MODIFICATION APPLICATION ASSESSMENT REPORT

Application Number:	Mod2022/0518
Responsible Officer:	Scott McInnes Creative Planning Solutions Pty Limited
Land to be developed (Address):	26 Ralston Road, Palm Beach NSW 2108 Lot 4, Sec. 10, DP 14048 Lot 5, Sec. 10, DP 14048
Proposed Development:	Modification of Development Consent DA2020/0096 granted for demolition of a dwelling house and construction of two dwelling houses.
Zoning:	C4 Environmental Living
Development Permissible:	Yes
Existing Use Rights:	No
Consent Authority:	Northern Beaches Council
Land and Environment Court Action:	No
Owner:	Tony Melhem Nassif
Applicant:	Tony Nassif
Application Lodged:	04/10/2022
Integrated Development:	No
Designated Development:	No
State Reporting Category:	Refer to Development Application
Notified:	11/10/2022 to 25/10/2022
Advertised:	Not Advertised
Submissions Received:	Three (3) submissions received
Clause 4.6 Variation:	No
Recommendation:	Refusal

The s.4.55(2) application seeks modification of DA2020/0096, which granted consent for demolition of a dwelling house and construction of two dwelling houses.

Figure 9: Height pole location survey at the subject site

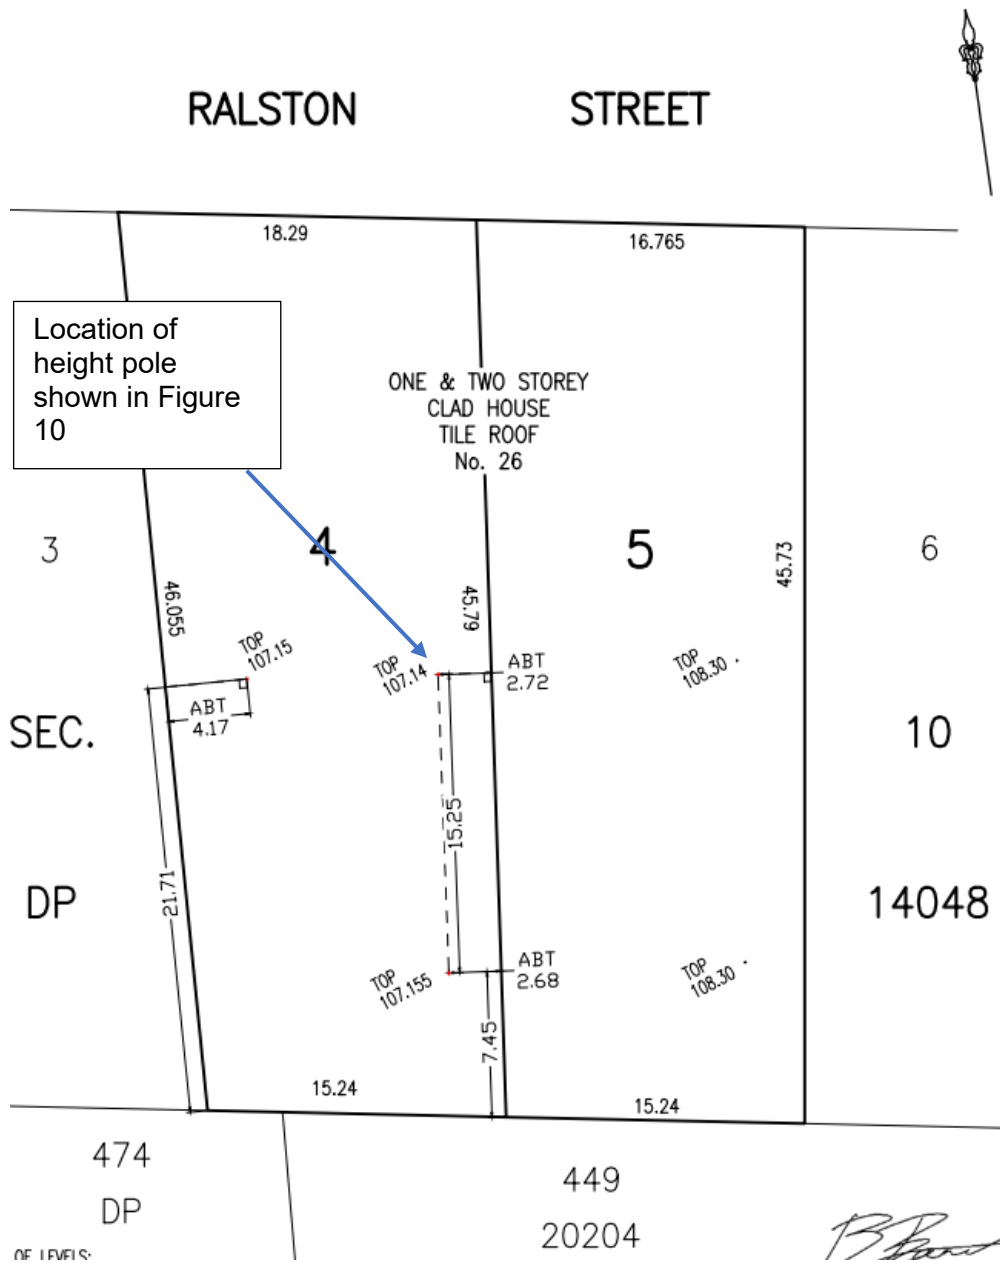
Regarding the above, the openings to the north facing living room on the second storey will be adversely affected by the proposed height increase. Based on the height pole in **Figure 9** and **10** the existing view is likely to be adversely impacted by obstructing more than 50% of the Broken Bay water view and degrading the land/water interface which is currently enjoyed from the living area. It is important to note that the top of the height pole level is RL107.14 and is 60mm lower than the maximum proposed parapet level of RL107.20 for Lot 4 and also does not include the levels for the roof top glass balustrade and is therefore not an accurate reflection of the proposed height shown on the section drawings. Despite this inconsistency, Council's view share analysis can still reach a reasonable conclusion regarding view impact.

- c) Despite the adverse view loss impacts the height poles shown on the survey plan, prepared by Brandon Bowd and dated 01/03/2023 do not reflect the proposed parapet levels or include the glass balustrade shown on Section Drawings A310 (Issue 04) prepared by Crawford Architects and dated 26/09/2022.
